# CUSTOMER ADVISORY

## ADV2002

### Label Content Update for FPGA and Power Products

**Table 2: Label Sample with “RoHS COMPLIANT”**

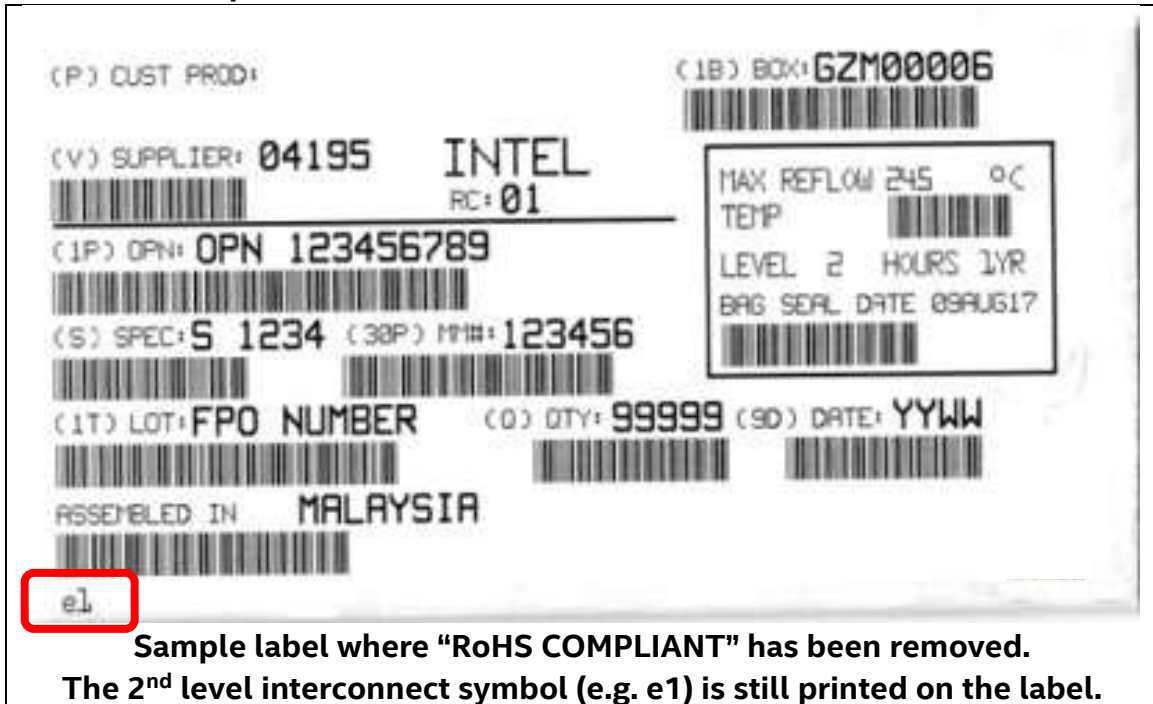
Change From	Change To
"RoHS COMPLIANT" indicated on the lower left of the barcode label	Labels may or may not indicate " <b>RoHS COMPLIANT</b> " on the barcode label.  The 2nd level interconnect symbol (e.g. e1) remains printed on the label.
